MONTGOMERY COUNTY PLANNING DEPARTMENT
THE MARYLAND-NATIONAL CAPITAL PARK AND PLANNING COMMISSION

MEMORANDUM

REVIEW TYPE: **Site Plan Review**
Final Water Quality Plan
CASE #: **820060110**
PROJECT NAME: **Bowie Mill Estates**

APPLYING FOR: Approval of 158 one-family detached and 28 one-family attached residential units, including a minimum of 15% (28) moderately priced dwelling units (MPDUs), on 438.2 acres
REVIEW BASIS: Div. 59-D-3 of Montgomery County Zoning Ordinance

II. Rural Open Space Dedication

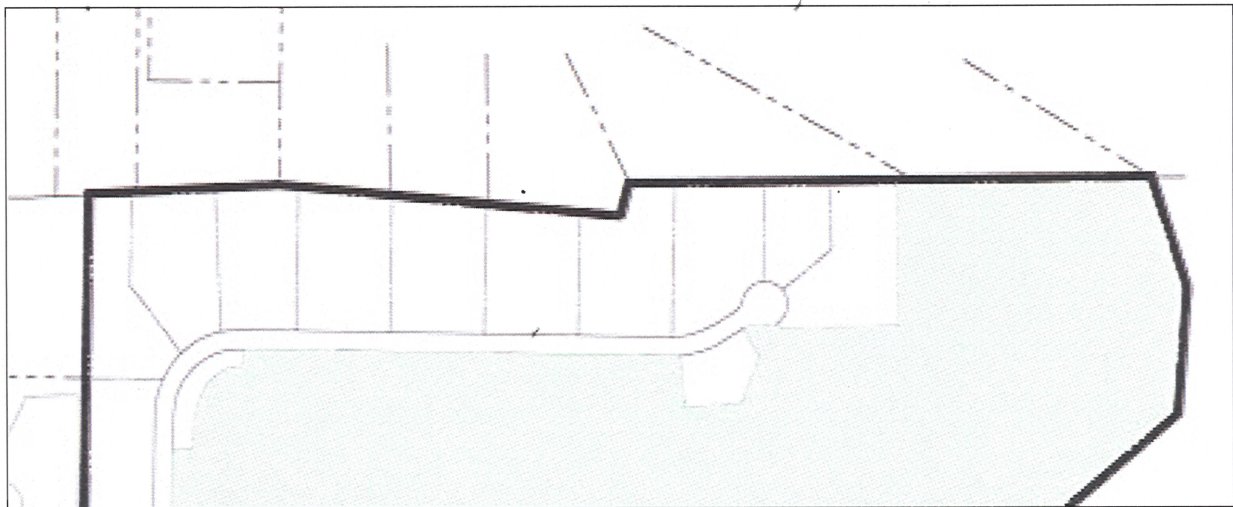
The RNC zone requires that 65-85% percent of the site be preserved as rural open space. During the hearing for Preliminary Plan 120060320, the Planning Board devoted substantial discussion to which method of conveyance would be most appropriate for the 268 acres of rural open space proposed for dedication to M-NCPPC. The RNC zone requires, at section 59-C-9.57(4), that:

From the discussion at the hearing, staff reviewed two basic alternatives. The first would dedicate ownership to the Homeowners' Association (HOA), which would in turn grant an easement in perpetuity to M-NCPPC for the management of the rural open space land. The second would dedicate the land to M-NCPPC with a covenant in the deed restricting management and use per the zoning and the Upper Rock Creek Master Plan. This alternative would require management of the Rural Open Space to be accepted by M-NCPPC. M-NCPPC staff unanimously recommended dedication of the rural open space to M-NCPPC with a covenant upon the land for compliance with the zoning and Upper Rock Creek Master Plan. Staff believes M-NCPPC is in the best position with the best interest to maintain the rural open space in keeping with the zoning and master plan.

Proposed Lot Configuration Along the Northern Site Boundary

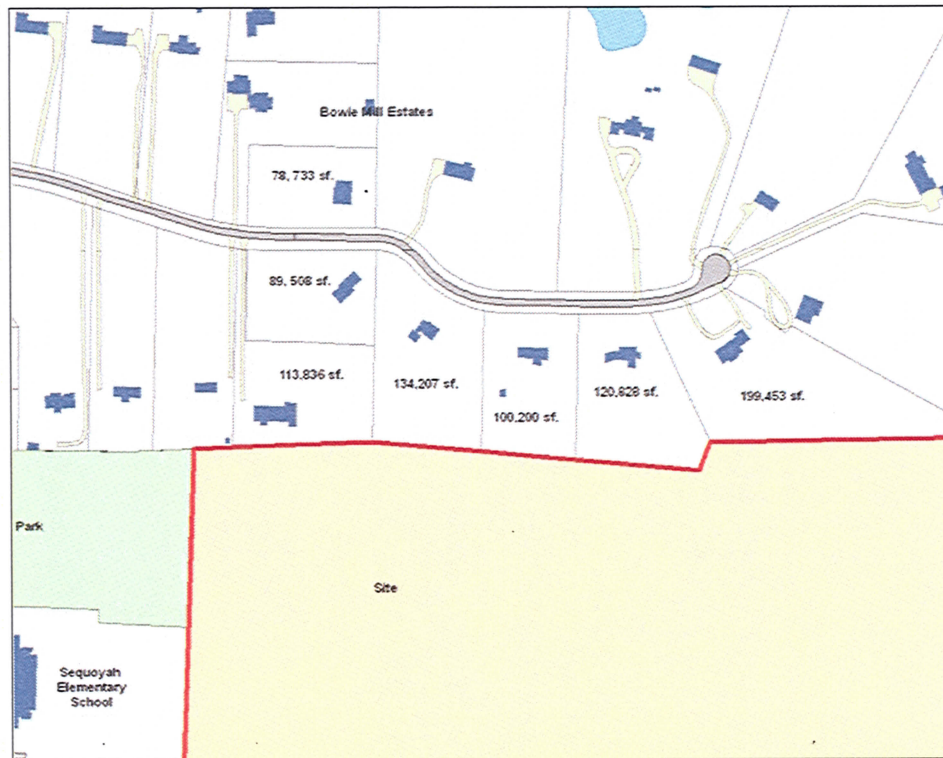
Another issue staff addressed with the applicant is the compatibility of the proposed lot sizes along the northern boundary of the site, directly adjacent to the existing lots on Foggy Lane. The Bowie Mill Civic Association, representing the existing Bowie Mill Estates, has expressed concern that the lots at the northern edge of the proposed site plan are not large enough to be compatible with the existing lots. In response to this concern, staff requested that the applicant reduce the number of lots proposed on that boundary.

Consistent with staff recommendation, the applicant has reduced the number of proposed lots along the northern boundary from nine to eight. These eight lots range in size from 78,769 sf. to 91,071 sf., with an average lot size is 85,441 sf., approximately two acres. The existing lots immediately adjacent range in size from 113,836 sf. to 199,455 sf. with an average lot size of 133,705 sf., or approximately three acres. But within the existing Bowie Mill Estates development, there are two lots on Foggy Lane that are considerably smaller, relatively speaking, at 78,733 sf. and 89,508 sf. – about two acres. The average proposed lot size, 85,441 sf., is comparable in size with the smaller lots within the existing lots on Foggy Lane, indeed larger than the smallest.

Staff supports the reduction in number and associated increase in size of the lots. Staff believes the increased size and proposed depths of the lots along the northern boundary of the site are compatible with the adjacent lots and in keeping with the Rural Neighborhood Cluster zone and the Upper Rock Creek Master Plan.
